August 16, 2011

Subject: Response to WDNR Correspondence dated April 18, 2011
Martinizing Dry Cleaning Site
1730 State Street
Racine, Wisconsin
BRRTS No. 02-52-549890
FID No. 252251010
Project No. 1E-0909013

FIGURE 3
 CROSS-SECTION LOCATION PLAN
 MARTINIZING
 1730 STATE STREET
 RACINE, WISCONSIN

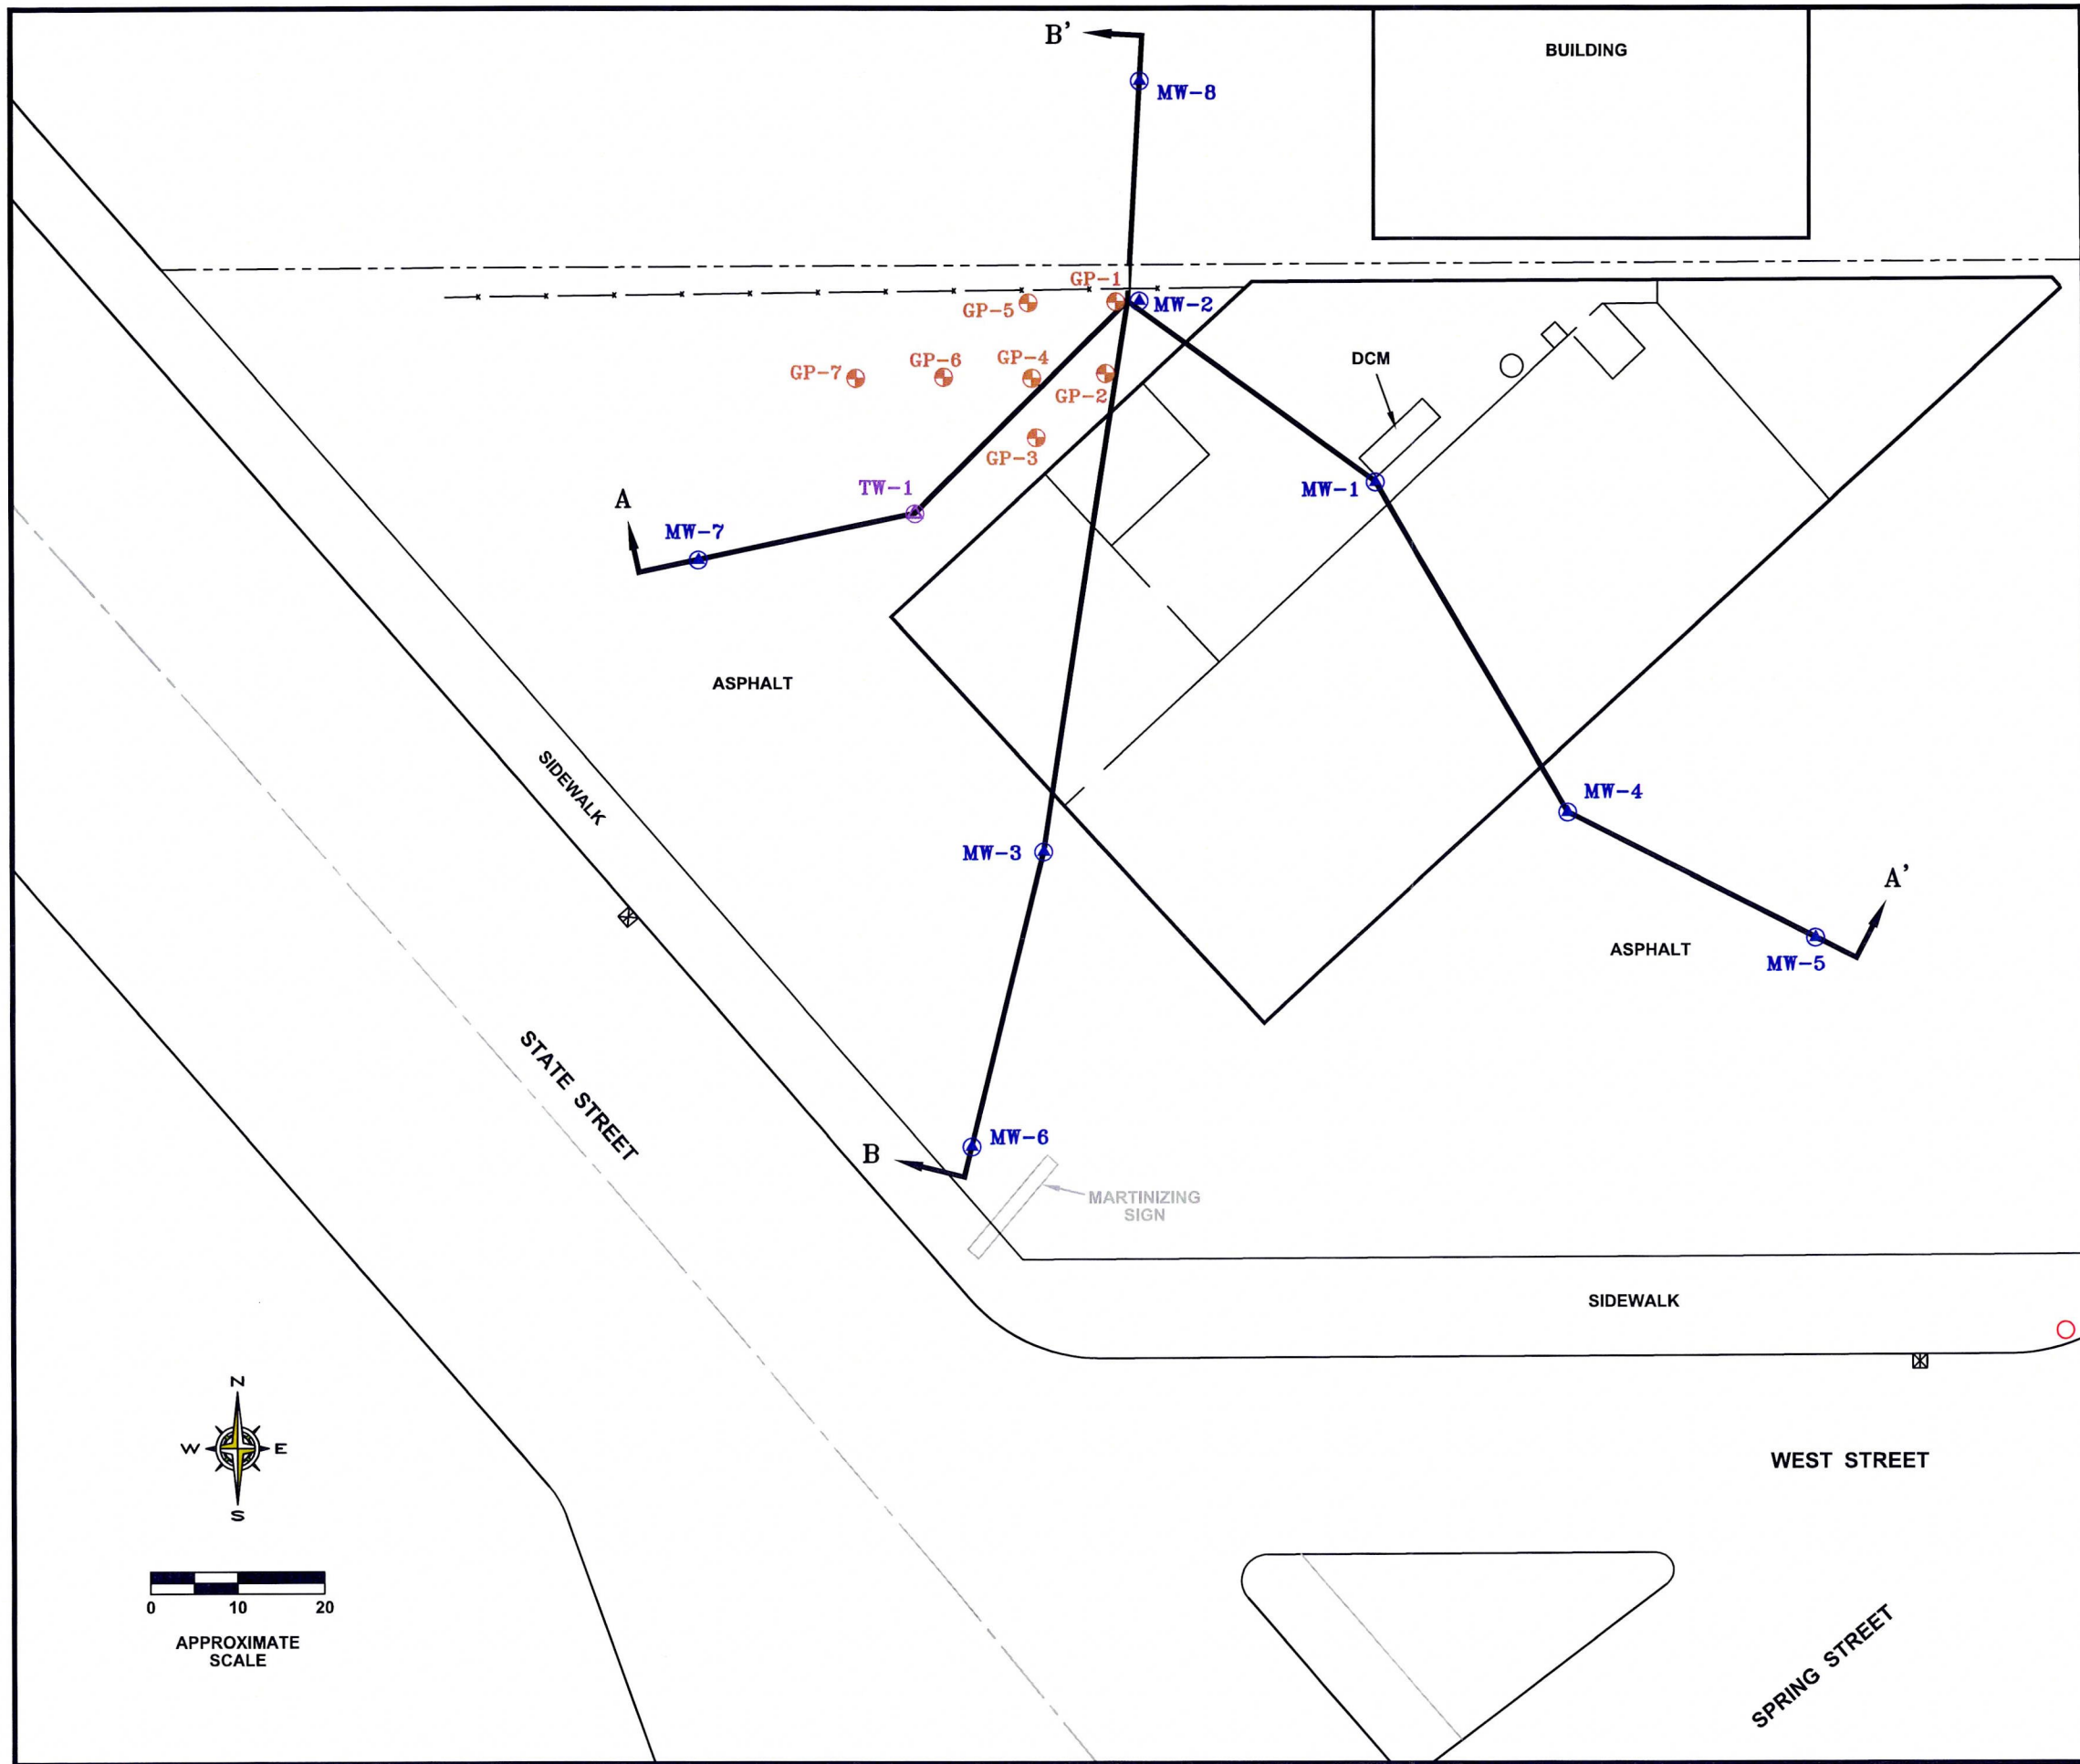
6. Have your consultant develop cross sections for this site. It appears that there are some anomalies with the geology that could impact the remedial action phase of this project.

Please see the attached cross-sections in accordance the WDNR's request.
